Interactive comment on “Monitoring of the reconstruction process in a high mountainous area affected by a large earthquake and subsequent debris flows” by Chenxiao Tang et al.

Received and published: 18 December 2019

Dear referee 2

Fig. 1.

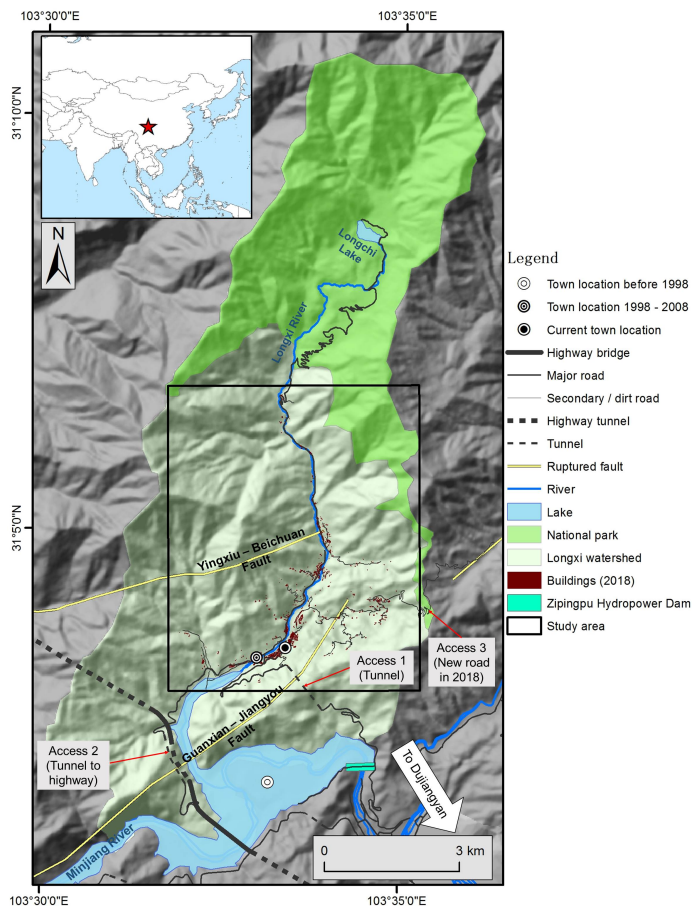
Your comment: Figures: fonts are too small, Figures need north arrow, measured grid and maybe an inlet showing the case study area in China.

Reply: Most of the figures are designed to be printed in full or nearly full page size to make elements visible and the font size was designed to fit for that. North arrows have been added in all maps. A grid and an inlet map have been added in Figure 1.
